PALISADES PLANT

AMENDMENT TO PROVISIONAL OPERATING LICENSE

Amendment No. 21
License No. DPR-20

ATTACHMENT TO LICENSE AMENDMENT NO.

PALISADES PLANT
 CONTROL ROD INSERTION LIMITS
 ALLOWED POWER LEVEL (% OF 2200 Mw_t) VS CONTROL ROD INSERTION (%) BY ROD GROUP
 FOR OPERATION BELOW 1900 psia

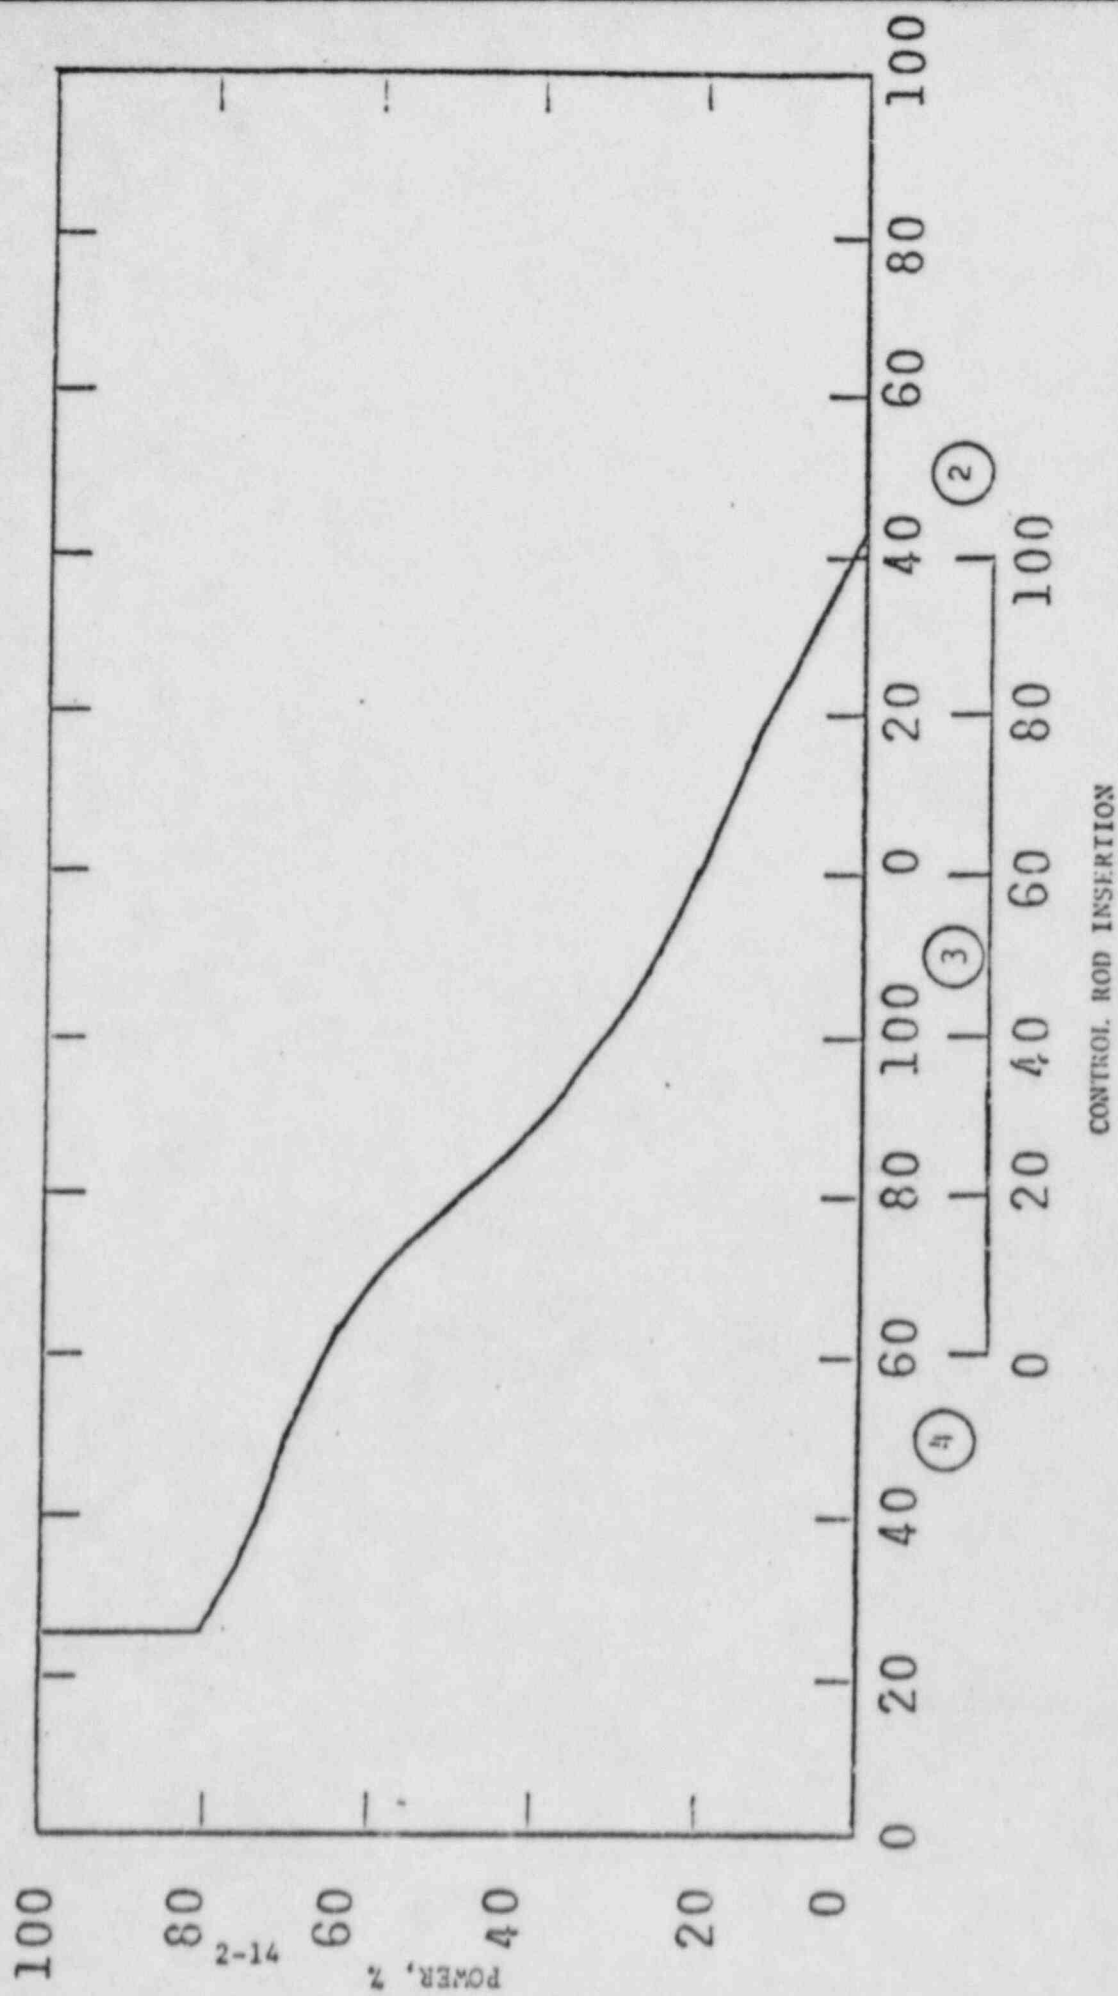
- a. To implement the limits on shutdown margin, individual rod worth and hot channel factors, the limits on control rod regulating group insertion shall be established as shown on Figure 3-6. These limits may be revised during fuel cycle life based on physics calculations and physics data obtained during plant start-up and subsequent operation.
- b. The sequence of withdrawal of the regulating groups shall be 1, 2, 3, 4.
- c. An overlap of control banks in excess of 40% shall not be permitted.
- d. If the reactor is subcritical, the rod position at which criticality could be achieved if the control rods were withdrawn in normal sequence shall not be lower than the insertion limit for zero power shown on Figure 3-6.

Figure
3-5

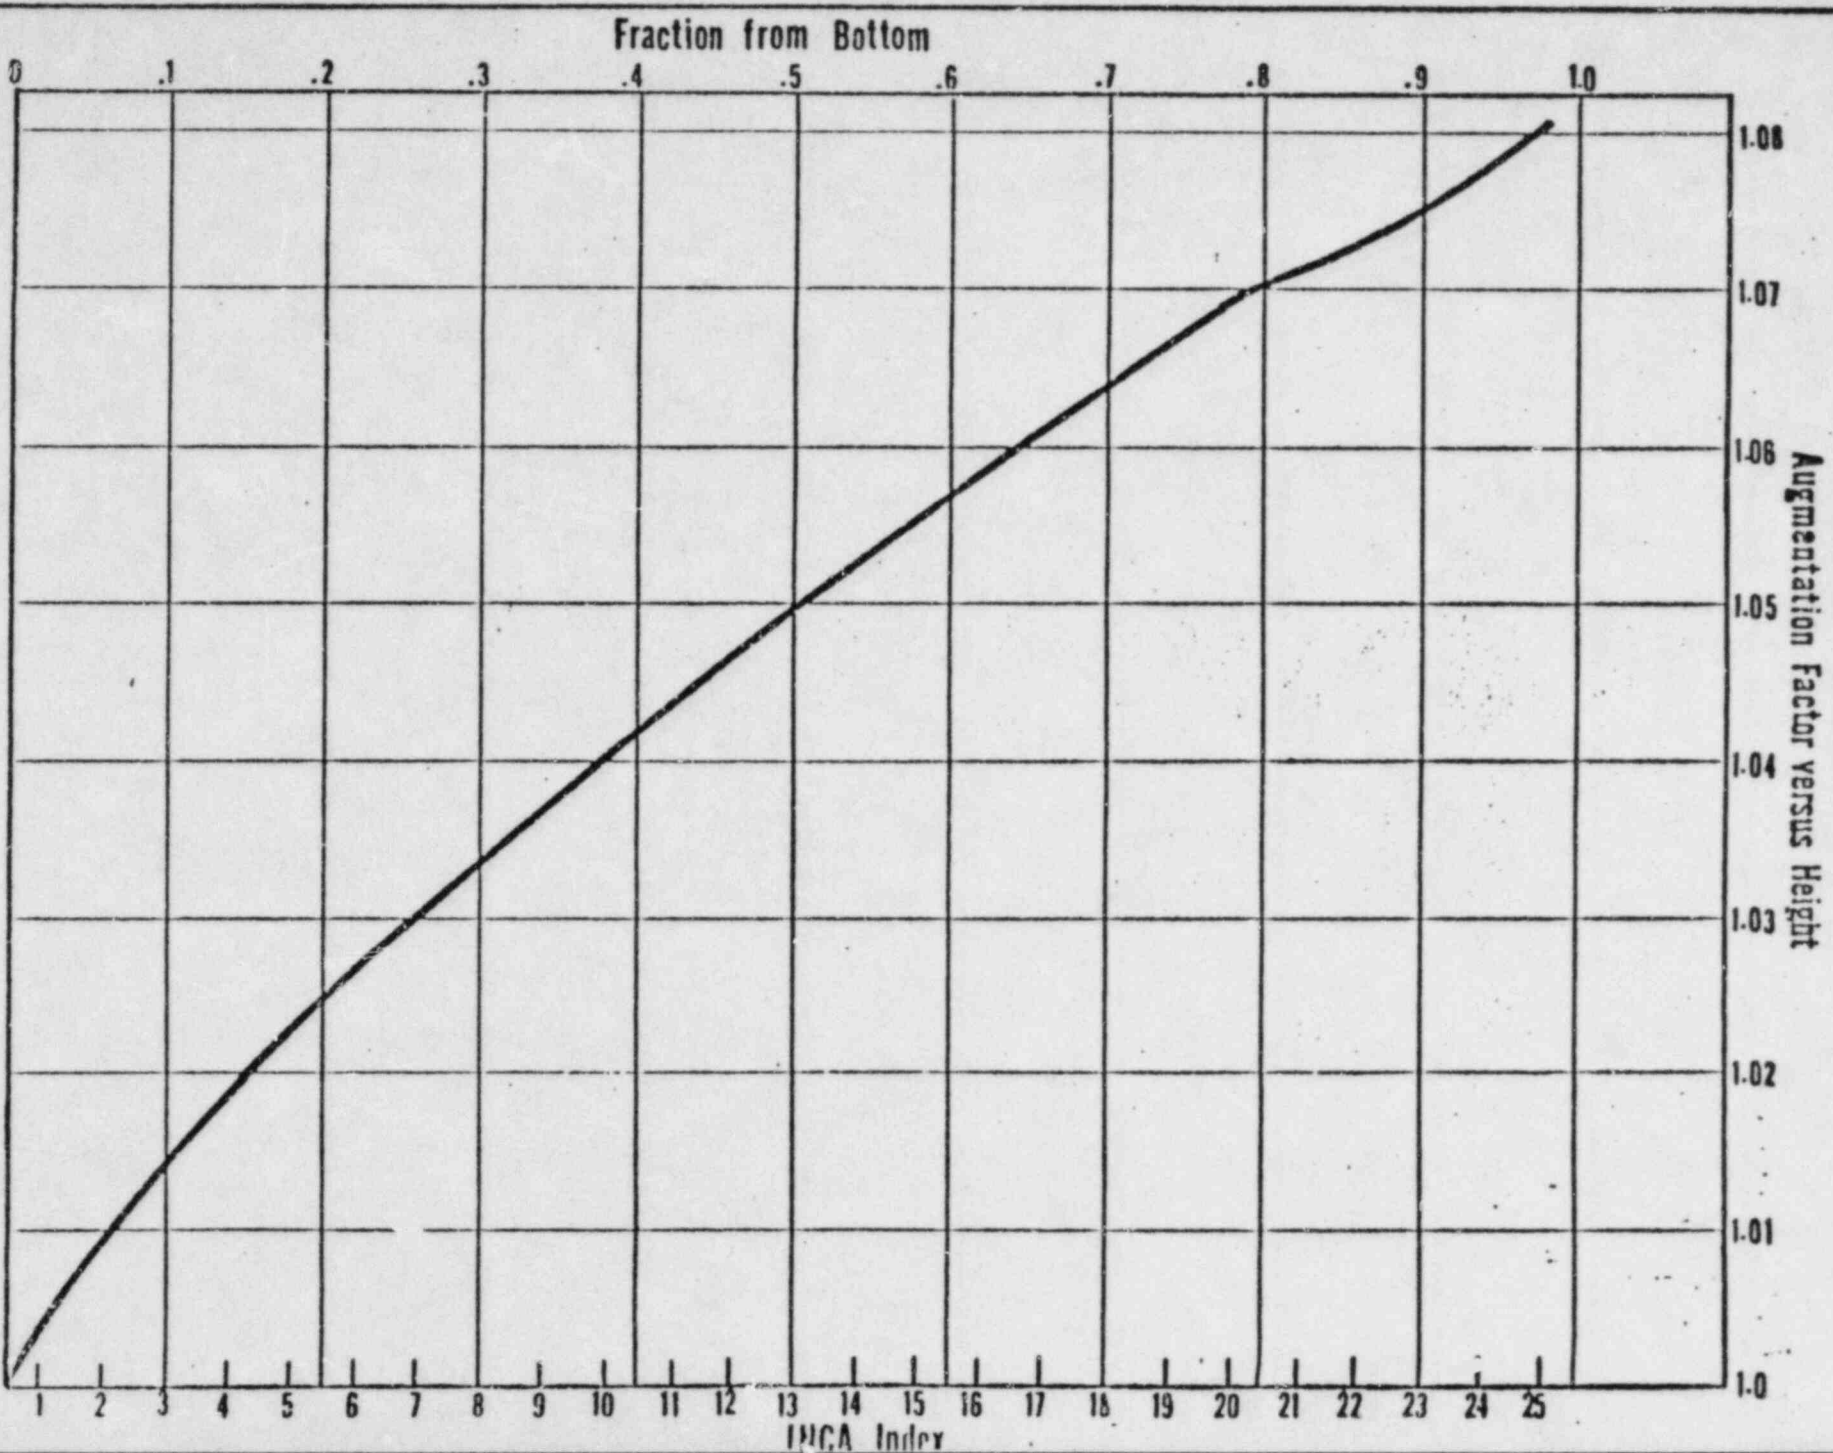
The measurement-calculational uncertainty shall be 10%, the engineering factor shall be 3%, the increase in linear heat rate due to axial densification shall be 1.75% (as applied to hot dimensions), the power measurement uncertainty shall be 2%, and the flux peaking augmentation factor shall be as given in Figure 3-7 for uncollapsed fuel and Figure 3-8 for collapsed fuel. Augmentation factors for pressurized densification resistant ENC fuel and pressurized high density CE fuel shall be 1.0.
